Sydney North Planning Panel Meeting 06 August 2025
S4.55(2) at 1 Gatacre Avenue and 5 Allison Avenue Lane Cove

Subject: S4.55(2) at 1 Gatacre Avenue and 5 Allison Avenue Lane Cove

Record No: DA24/35-01 - 42170/25

DA Number	Council Reference: DA35/2024 Portal Reference: PPSSNH-660
Proposed Development	s4.55(2) modification to approved development for demolition of existing structures, lot consolidation and construction of a Part 4, Part 5 and Part 6 residential flat building with 43 apartments and two levels of basement parking with 85 parking spaces.
Street Address	1 Gatacre and 5 Allison Avenue Lane Cove
Applicant	Patch Planning
Owner	Gatacre LC Pty Ltd
Date of DA Lodgement	22 May 2025
Public Notification	Notification Period: 22 May 2025 to 7 June 2025
Total number of unique Submissions Received	27 unique submissions. All submissions forwarded to the SNPP for consideration.
Recommendation	Approval :- In part - subject to recommended draft conditions requiring design changes.
Regional Development Criteria	The proposal is referred to the Sydney North Planning Panel as more than 10 public submissions were received as a result of the notification period. Under section 3.3 <i>Classe

Figure 2: Height Plane Plan (Source: PBD)

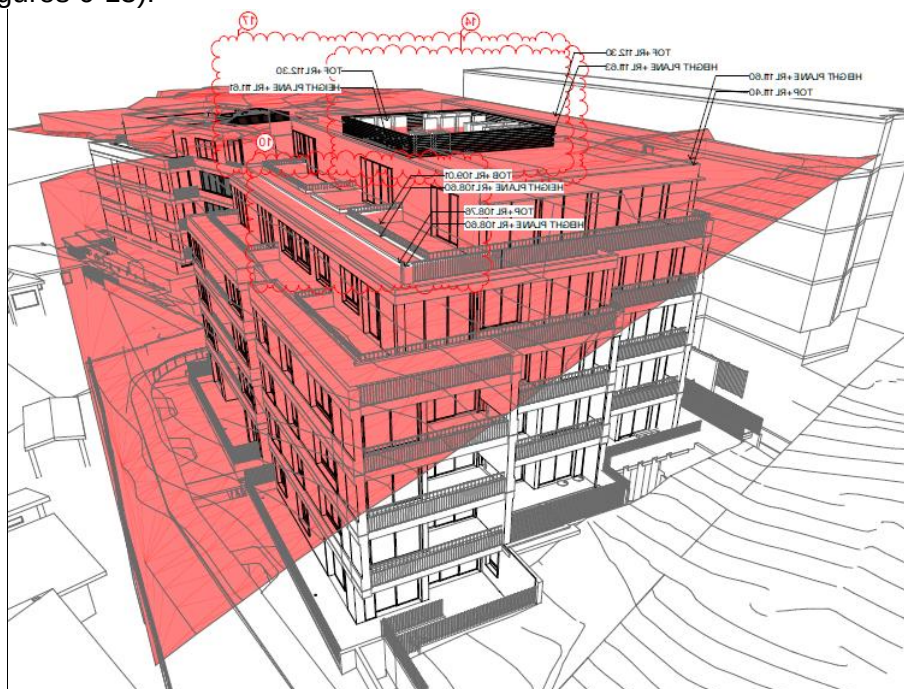
It is noted that the design of the roof top plant and enclosure has been amended since lodgement. The total variation to the height control has been reduced by approximately 60cm. The maximum variation would be 0.69m resulting in a total height of 15.69m or an RL.112.30.

The variation to the height control is limited to a mechanical plant acoustic enclosure and the AC condenser units within enclosure on the roof and 7m from the northern boundary. The variation of an additional 69cm would not result in unacceptable overshadowing impacts compared to the approved building envelope as demonstrated in the shadow diagrams.

Figure 6:

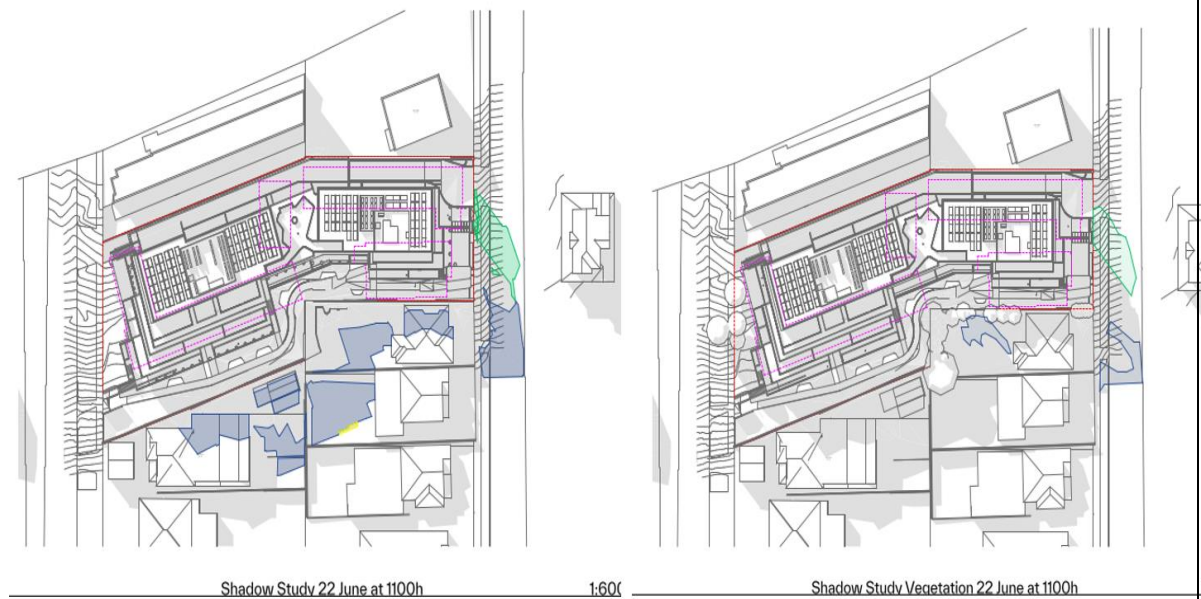
Figure 6: Mid-winter 11am. Discounting the shadows cast from existing vegetation, a small portion of additional shadow to rear yard of 9 Allison Avenue. The rear yard would still achieve an area of approximately 37sqm of solar access.

Figure 7: Mid-winter 11am. Shadows cast by the modification would fall within existing shadows cast by trees and vegetation.

Figure 8: Mid-winter 12pm. Discounting the shadows cast from existing vegetation, a small portion of additional shadow to rear yard of 9 Allison Avenue. The rear yard would still achieve an area of approximately 103sqm of solar access

Figure 9: Mid-winter 12pm. Shadows cast by the modification would fall within existing shadows cast by trees and vegetation.

Figure 10:

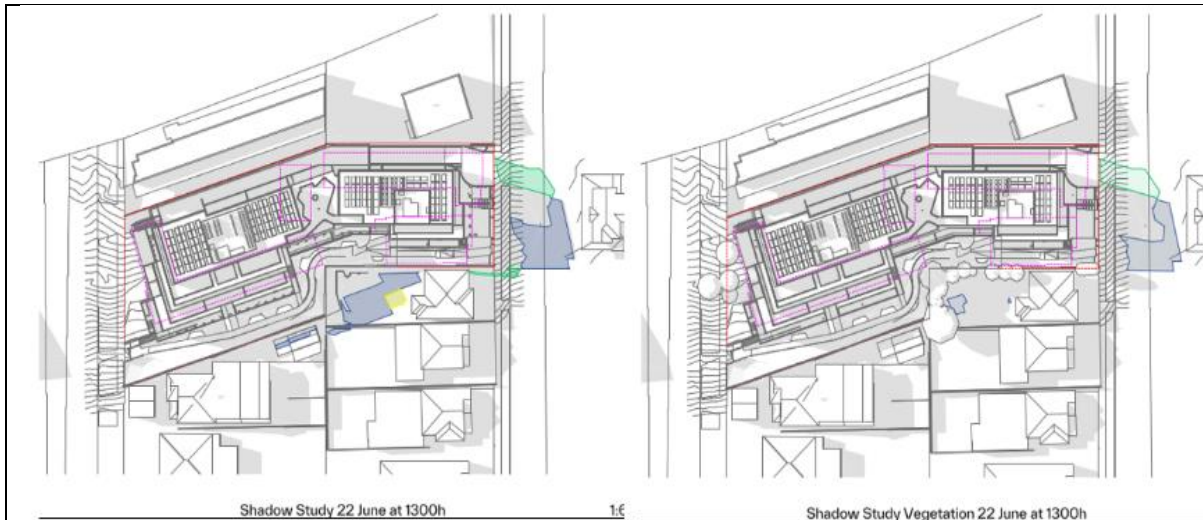
Figure 10: Mid-winter 1pm. Discounting the shadows cast from existing vegetation, a small portion of additional shadow to rear yard of 7 Allison Avenue. The rear yard would still achieve an area of approximately 40sqm of solar access.

Figure 11: Mid-winter 1pm. Shadows cast by the modification would fall within existing shadows cast by trees and vegetation.

Figure 12:

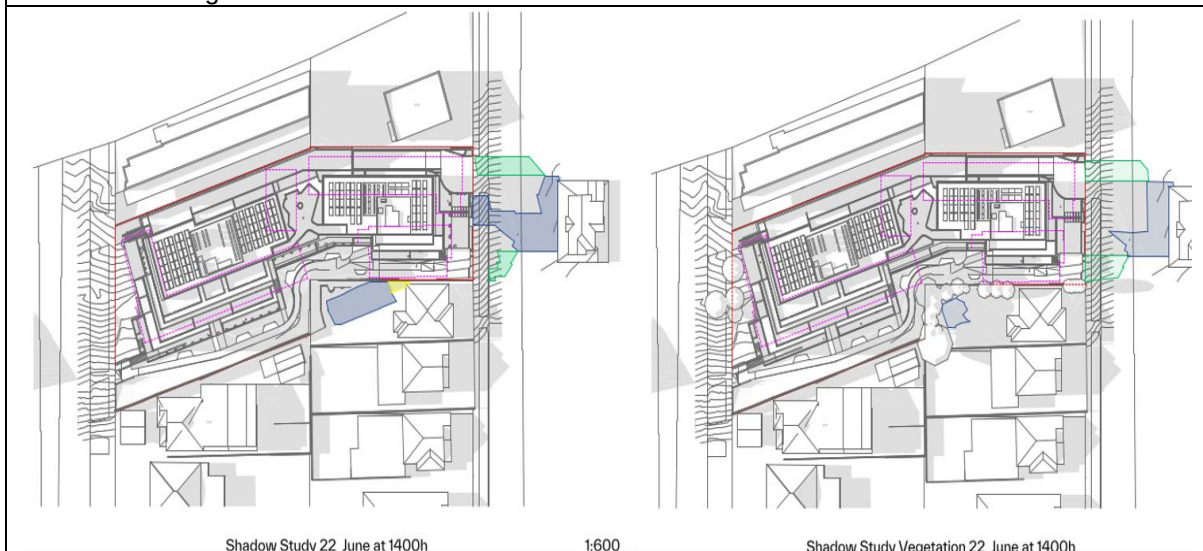
Figure 12: Mid-winter 2pm. Discounting the shadows cast from existing vegetation, a small portion of additional shadow to rear yard of 7 Allison Avenue. The rear yard would still achieve an area of approximately 100sqm of solar access.

Figure 13: Mid-winter 2pm. Shadows cast by the modification would fall within existing shadows cast by trees and vegetation.

Figures 14 and 15: Excerpt of level 2 (4th storey) proposed (left) and approved (right). (Source: PBD)

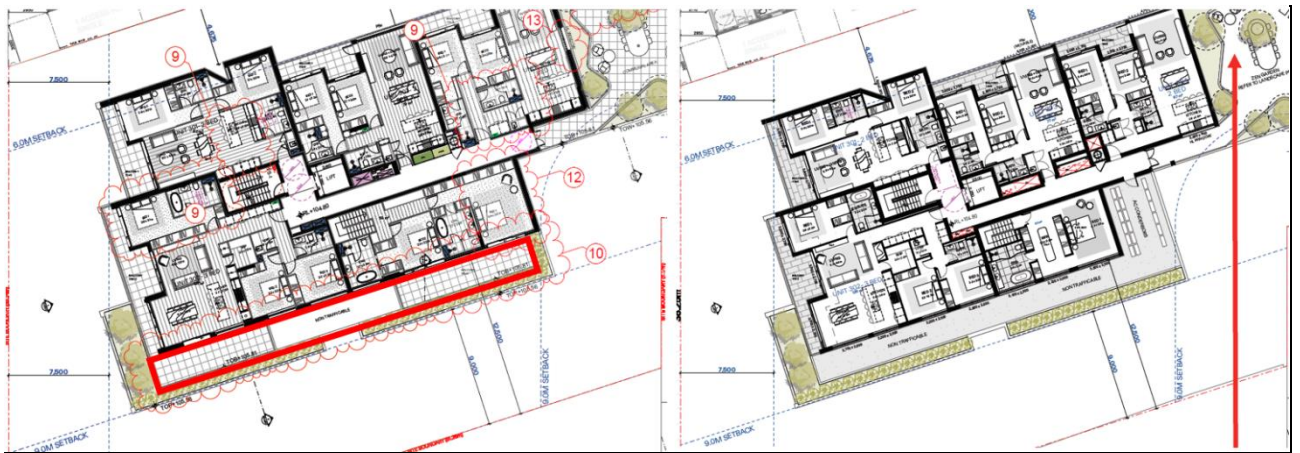
- 4th storey (2F) trafficable balcony would be setback approximately 9m from the boundary of 2 and 2A Gatacre; The balcony would increase in area from 12sqm to 17sqm by reducing the depth of the open plan kitchen/dining/living room behind;
- 5th storey (3F) trafficable balconies would be setback approximately 10.35m from the boundary 2 and 2A Gatacre; and
- 6th storey (4F) trafficable balconies would be setback approximately 14.8m from the boundary of 2 and 2A Gatacre.

- 4th storey (2F): The s4.55 would not change to approved setback. The balcony depth of 2.6m would not increase. The changes are considered acceptable.

Figures 16 and 17: Excerpt of level 3 (5th storey) proposed (left) and approved (right). (Source: PBD)

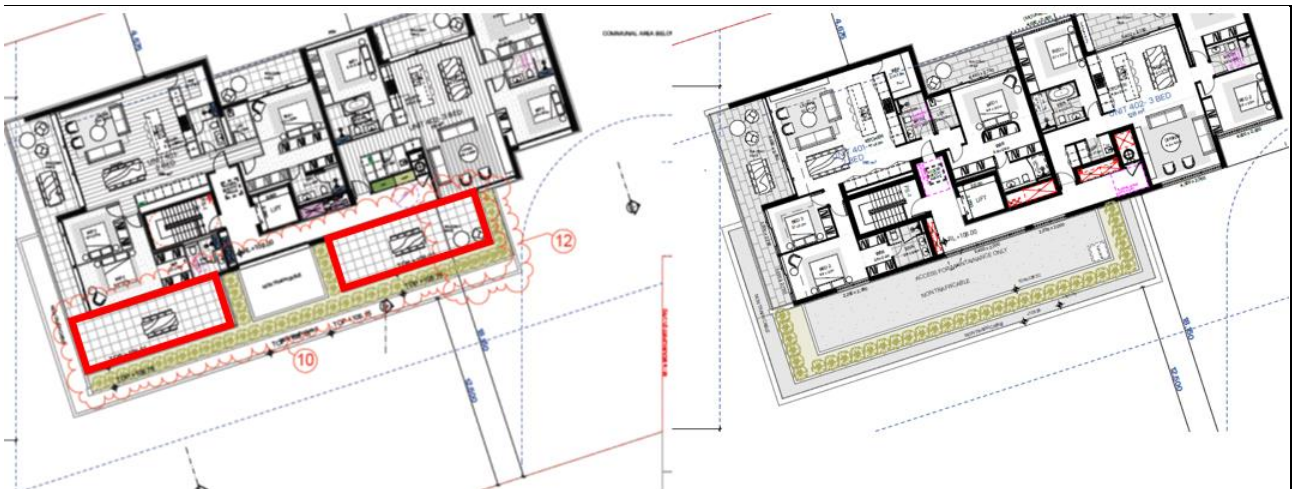
- 5th storey (3F): The s4.55 would result in a non-compliant 10.35m separation distance between the balcony on 5th floor and the property boundary. This is **not supported**, and a condition will be recommended requiring **the balconies to be deleted and be retained as non-trafficable**. (Refer to condition 2. (I) Design Amendments.)

- 6th storey (4F): The s4.55 would result in a 14.8m separation distance. While this complies with the required ADG separation distance, it would result in an additional south facing balcony and potential accumulative amenity impacts. The balconies would be approximately 3.2m in depth. The proposal is **not supported in its current form**. It is recommended that a **draft condition requiring increasing the depth of the non-trafficable raised planter box by a further 1.2m**. (Refer to condition 2. (J) Design Amendments.) The remaining trafficable area would be reduced to maximum depth of 2m. A minimum trafficable 2m depth would comply with section 3.11(a) Private Open Space – Balconies and terraces of Part C - Residential Development in the Lane Cove DCP. This would result in a reduced area being not capable of being used as an entertaining area and potential noise impacts. (See Figure 20).

Figure 23: Proposed high-sill windows on Unit 304 and Unit 305 on communal area. (Source: PBD)

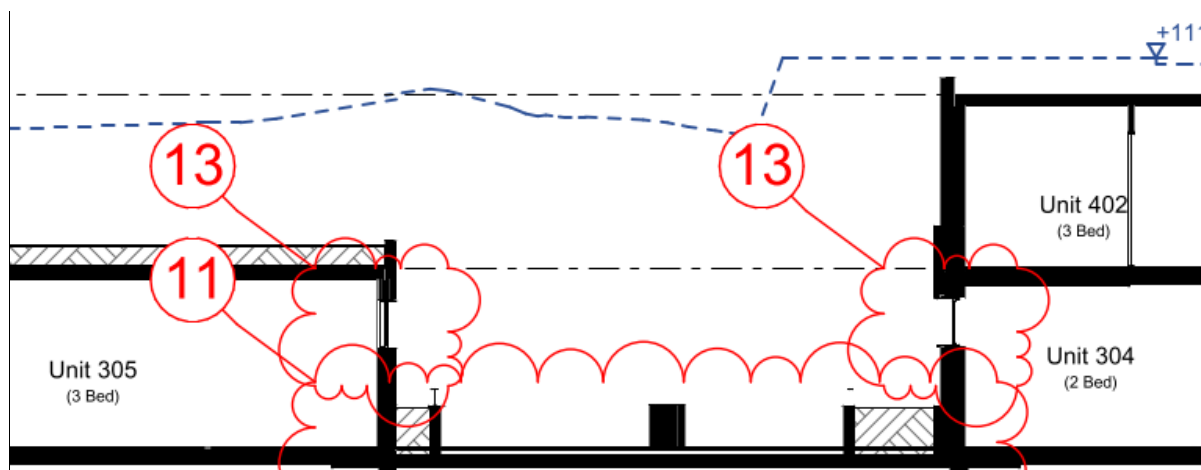
Proposed highlight windows on units 3.04 and 3.05 would have sill height of 1.7m above finished floor level and would face onto the level 3 communal open space. These windows would result in additional sources of natural light to the associated bedrooms without compromising their amenity. See Figure 23 below.

Recommendation: The additional high-sill windows are negligible in impact and are supported by Council.

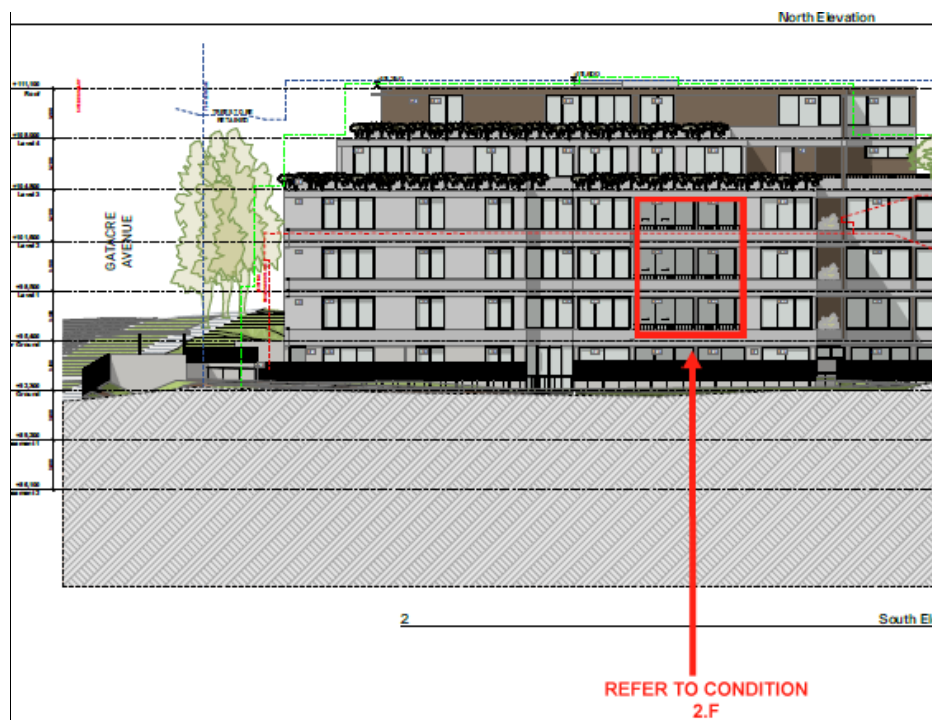
As per figures 24 and 25 above, the eastern-most oblique windows on levels 3, 4 and 5 are associated with bathrooms. The western-most oblique diagonal windows on levels 3, 4 and 5 are associated with a bedroom (level 3) and dining rooms (levels 4 and 5).

Comment: Allowing the diagonal oblique bathroom windows to be clear would result in sightlines to and from 7 Allison Avenue. The windows are permitted to be clear and operable above 1.6m above FFL to allow natural ventilation which is considered to be a balanced and reasonable outcome.

Recommendation: It is recommended that this condition requiring all diagonal oblique windows to be obscure inoperable up to 1.6m above FFL be retained.
